Design Review Board
September 10, 2024

STAFF REPORT
(For Courtesy Review)

Request: A courtesy review of building/architecture plan for the proposed Montessori School expansion.

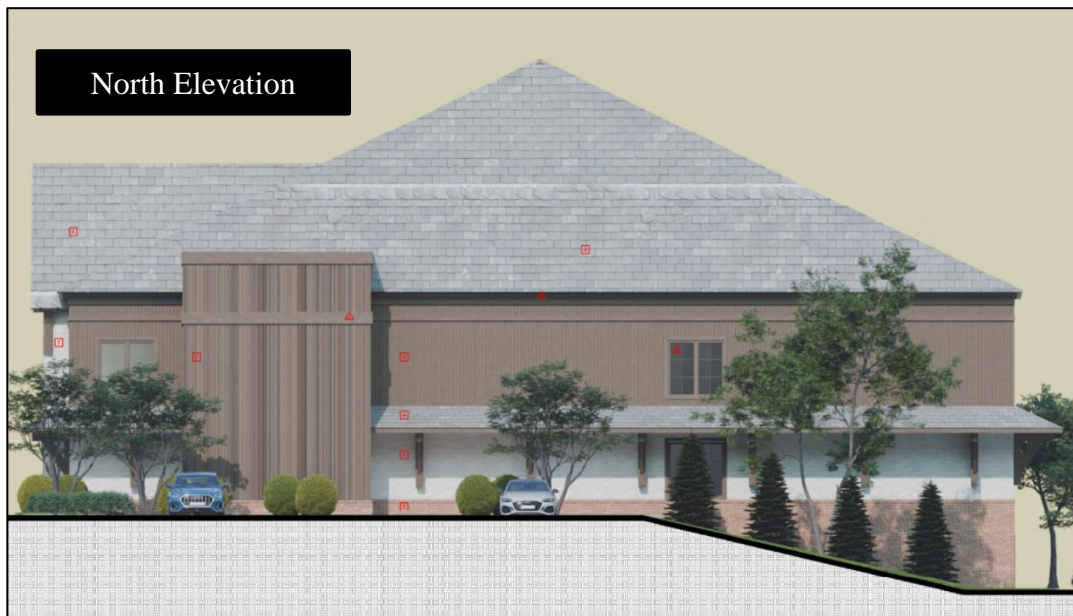
The image below shows the north (back) elevation of the building. This elevation faces the parking spaces and activity area. When phase 2 construction happens, the façade will completely change and will mimic the façade of the south (front) elevation.

Building entrances and front exteriors must be articulated and designed to create additional visual interest by varying architectural details, building materials, and by varying the roof line and building offsets. (Sec. 6.2.8 (M))	The proposed front elevation of the building shows a combination of brick, vertical wood siding, and wooden brackets for accents. The window sizes and placements are proportional. The addition of a flat roof canopy for the entryway and brackets and a vent on the gable creates some visual interest.
Exterior wall materials of nonresidential buildings...must be at least 75% brick or natural stone (measured as percent of wall area, per vertical wall plane). (Sec. 6.2.8 (N))	<p>The south (front) elevation and east elevation (the right side that faces Bethany Bend) show at least 75% brick. The water table, the projected wall at the center of the building and the gables are made of bricks.</p> <p>The west (left side) elevation shows at least 75% brick. The unfinished basement and first level are made of bricks while the second level shows vertical siding.</p> <p>The brick material on the north elevation (back of the building) appears to be less than 75%.</p>

1. Add an exterior door to the enclosed staircase area that faces Bethany Bend.
2. Confirm the roof pitch.
3. Improve landscaping in the north elevation (back of the building). The plan shows plants above concrete.
4. Provide a separate drawing for the pavilion and show building details.
